SUBJECT: DONALD C. COOK NUCLEAR PLANT, UNITS 1 AND 2 - ISSUANCE OF
AMENDMENTS (TAC NOS. MA8893 AND MA8894)

SAFETY EVALUATION BY THE OFFICE OF NUCLEAR REACTOR REGULATION
RELATED TO AMENDMENT NO. 249 TO FACILITY OPERATING LICENSE NO. DPR-58
AND AMENDMENT NO. 230 TO FACILITY OPERATING LICENSE NO. DPR-74
INDIANA MICHIGAN POWER COMPANY
DONALD C. COOK NUCLEAR PLANT, UNITS 1 AND 2
DOCKET NOS. 50-315 AND 50-316

Figure 1: Break Exclusion Zones
 (No Longitudinal or Circumferential Breaks, No Critical Cracks, No Terminal End Breaks)
 Typical for Both Units

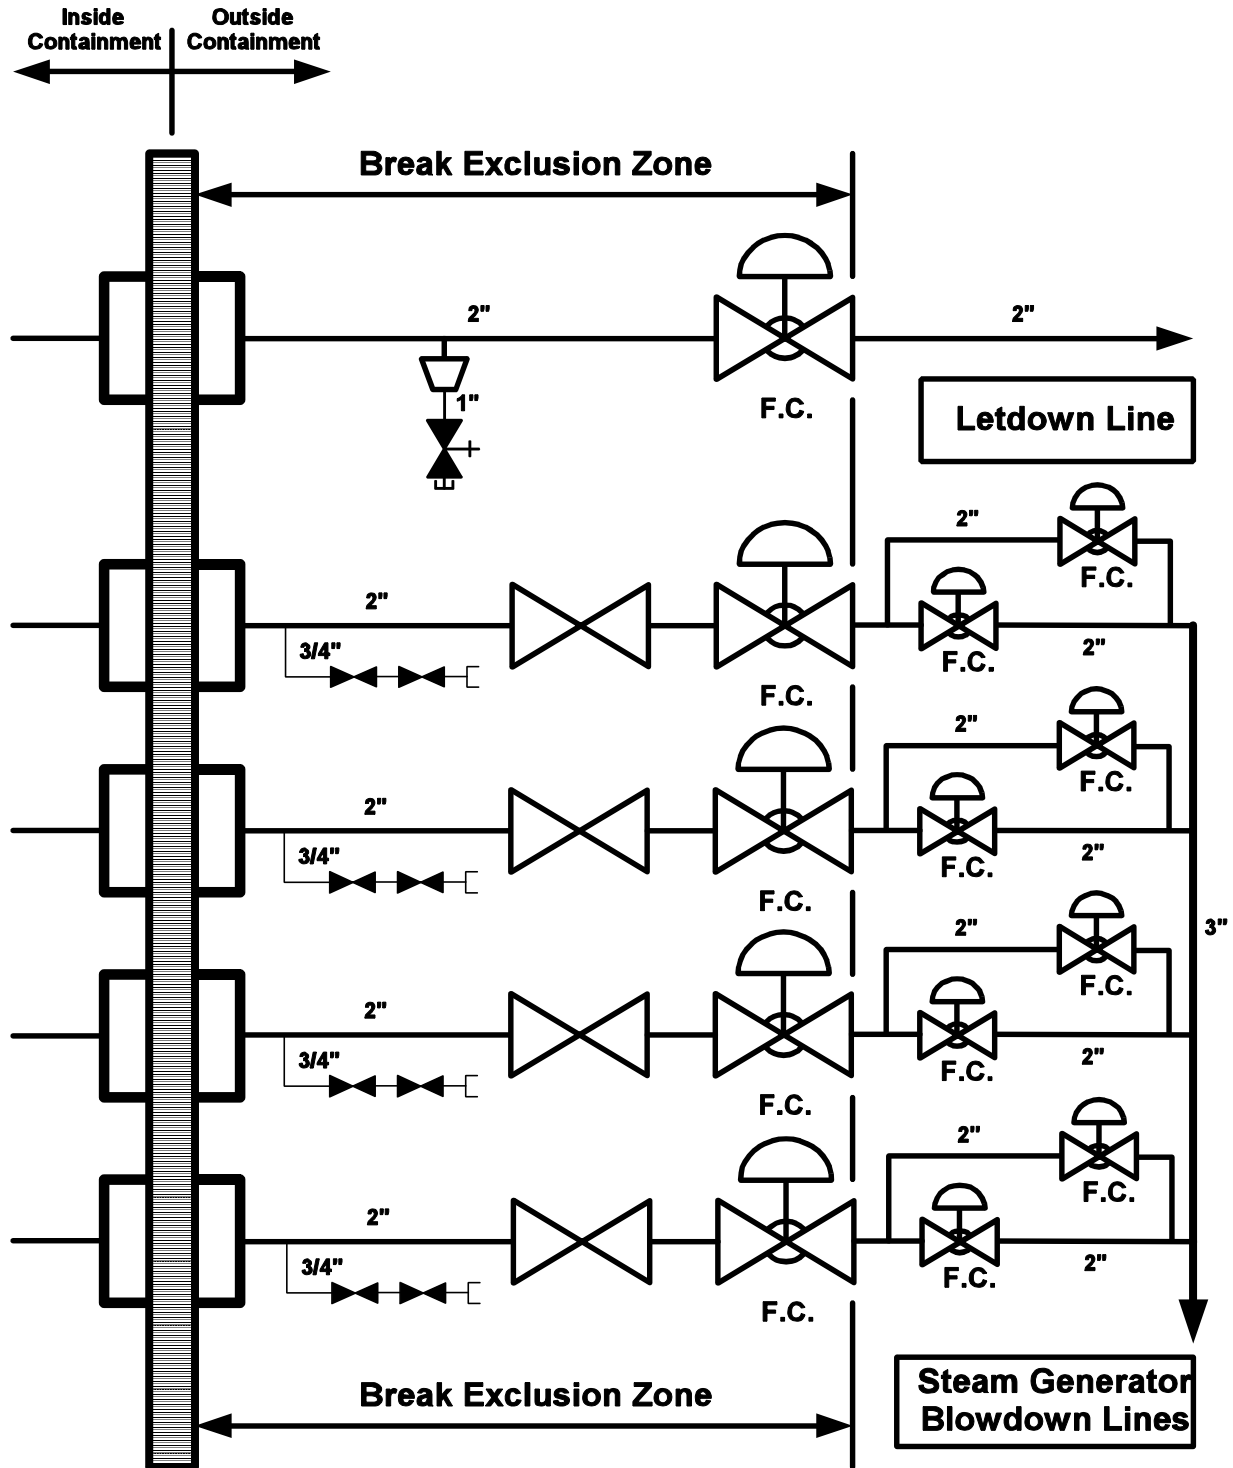
The licensee proposes to apply stress analyses based on USAS B31.1.0-1967, "USA Standard for Pressure Piping, Power Piping," the design code of record for piping at the D. C. Cook plant, for use with SRP 3.6.2, BTP MEB 3-1, Section B.1.b, to establish break exclusion zones. The application of SRP break exclusion zones is requested specifically for the steam generator blowdown (SGBD) and chemical volume control system (CVCS) letdown lines outside containment (see Figure 1).

The SRP Section 3.6.2, BTP MEB 3-1, Section B.1.b, provides for an exclusion from break and crack considerations in the containment penetration area for piping exiting penetrations up to the first isolation valve. As set forth in the SRP, such an exclusion is appropriate only if piping stresses are within specified limits and the piping cannot be adversely impacted by breaks or cracks in other parts of the piping. The licensee proposes to change the licensing and design basis of the piping to preclude the consideration of breaks and cracks in the portions of the SGBD and CVCS letdown lines in the containment penetration areas (designed under the provisions of the Giambusso letter) based on acceptable piping analysis in accordance with USAS B31.1.0-1967. The licensee has performed new detailed stress analyses on the piping in question to verify that the stresses in the piping are within the SRP identified limits. The new calculations identified a number of piping supports that required modifications. Modifications to the piping supports in Unit 2 have been completed and modifications for Unit 1 will be completed prior to Unit 1 entering into operational MODE 3 from its current extended outage.

The SGBD and CVCS letdown piping has been analyzed in accordance with USAS B31.1.0-1967, and support modifications have been performed to ensure that the piping stresses meet the Giambusso break limiting stress criterion of $0.8(S_h + S_a)$, which is lower than the SRP limiting stress criterion of $0.8(1.8S_h + S_a)$. The symbols S_h and S_a represent the allowable stress at maximum (hot) temperature and the allowable stress range for thermal expansion, respectively. The use of this approach to account for the differences between the American Society of Mechanical Engineers (ASME) Code stress methodology used in the SRP and the USAS B31.1.0-1967 stress methodology has been previously reviewed and approved by the NRC for use on USAS B31.1.0-1967 piping located inside containment at Crystal River, Unit 3, by letter dated September 28, 1989. Other requirements for the use of USAS B31.1.0-1967 and MEB 3-1 are also specified in this letter. The licensee stated that the revised analyses

conform with these provisions. The licensee has also evaluated the effects of breaks outside of the containment penetration area and determined that they do not have an adverse impact on the piping within the exclusion zone. The use of this methodology and the modification of the piping supports on the SGBD and CVCS letdown lines ensure a sufficient margin to preclude breaks and cracks in this region of piping. The use of lower limiting stress criteria for the postulation of breaks and cracks in the containment penetration areas of the SGBD and CVCS letdown lines will provide the necessary reasonable assurance for protection from HELB events.

Based on the above, the NRC staff finds the application of stresses calculated in accordance with USAS B31.1.0-1967, in conjunction with SRP BTP MEB 3-1, Section B.1.b, to the portions of SGBD and CVCS piping outside containment located between the containment penetration and the first outboard isolation valve is acceptable.

Figure 2: Steam Generator Blowdown Line Crack Exclusion
(No Critical Cracks)
Units 1 & 2

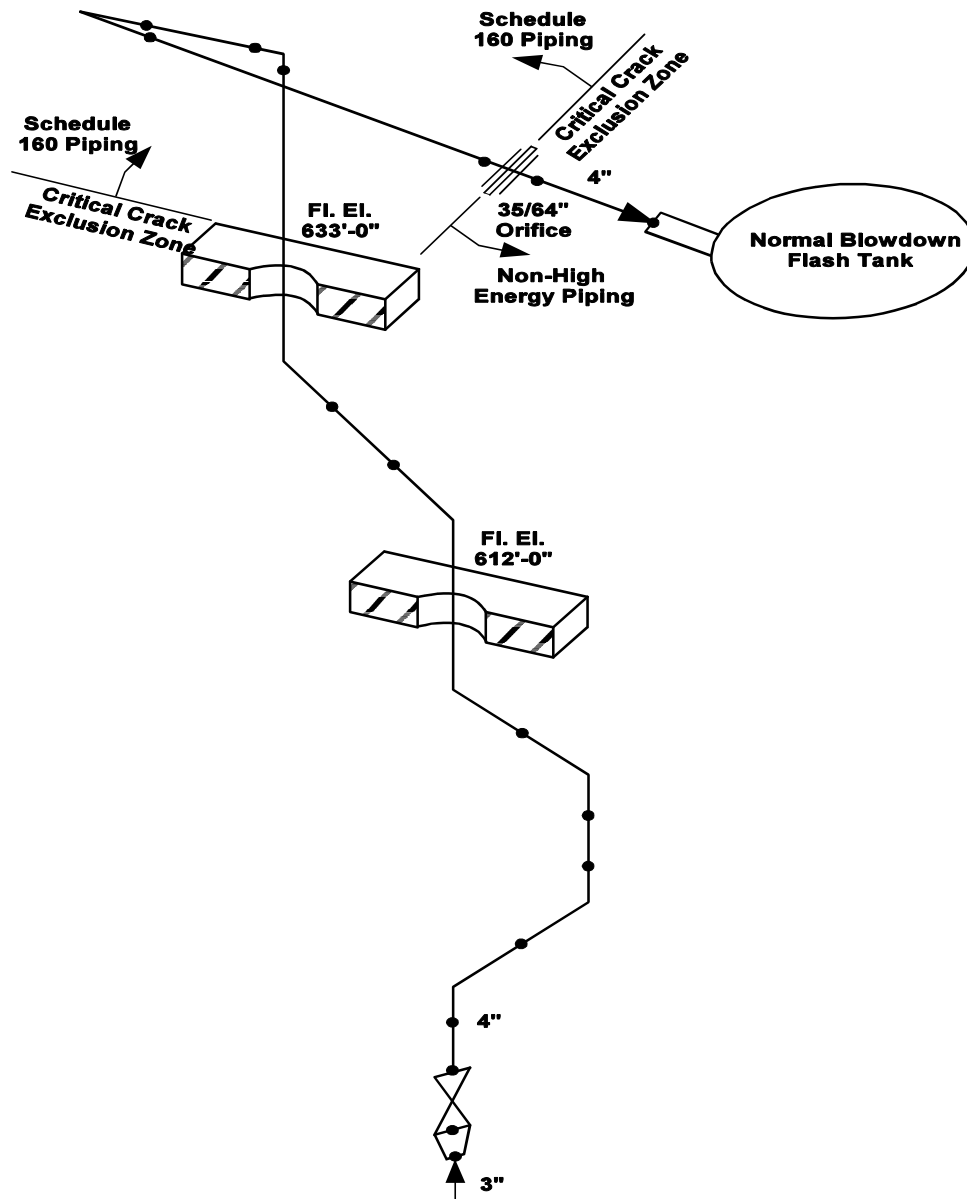
The licensee intends to apply this methodology to a portion of SGBD piping located in the normal flash tank room in Units 1 and 2 (see Figure 2), to eliminate the postulation of a crack in this piping as would be required under the Giambusso letter. This modifies the licensing and design basis for this portion of piping.

The licensee performed new calculations on the piping in question based on USAS B31.1.0-1967 and discovered that approximately 10 feet of piping in Unit 2 needed to be replaced with heavy wall piping, and the piping supports in both Units 1 and 2 needed to be modified, so that the applied stresses met the limiting stress criterion. By letter dated November 13, 2000, the licensee clarified the April 6, 2000, application by indicating that the SRP methodology for crack postulation for the SGBD piping in the normal flash tank room in Unit 1 was required.

The use of piping stresses based on USAS B31.1.0-1967 to predict crack postulation based on the SRP methodology and the limiting stress criterion for cracks stated in the NRC letter September 28, 1989, is acceptable and conservative. This methodology for the postulation of cracks in the SGBD piping in the normal flash tank rooms is conservative and provides the margin to failure, which is inherent in the material properties and allowables of the SGBD piping. The replacement of the normal piping with heavy wall piping in Unit 2, piping support

modifications, in the new stress calculations based on USAS B31.1.0-1967, in conjunction with the conditions and the limiting stress criterion for crack postulation, provides reasonable assurance that the stresses in the SGBD piping are sufficiently low to exclude the SGBD piping from crack formation.

Based on the above, the NRC staff finds the application of stresses calculated in accordance with USAS B31.1.0-1967, in conjunction with SRP BTP MEB 3-1, Section B.1.e, to the portions of the SGBD piping outside containment located in the normal flash tank rooms in Units 1 and 2 is acceptable.
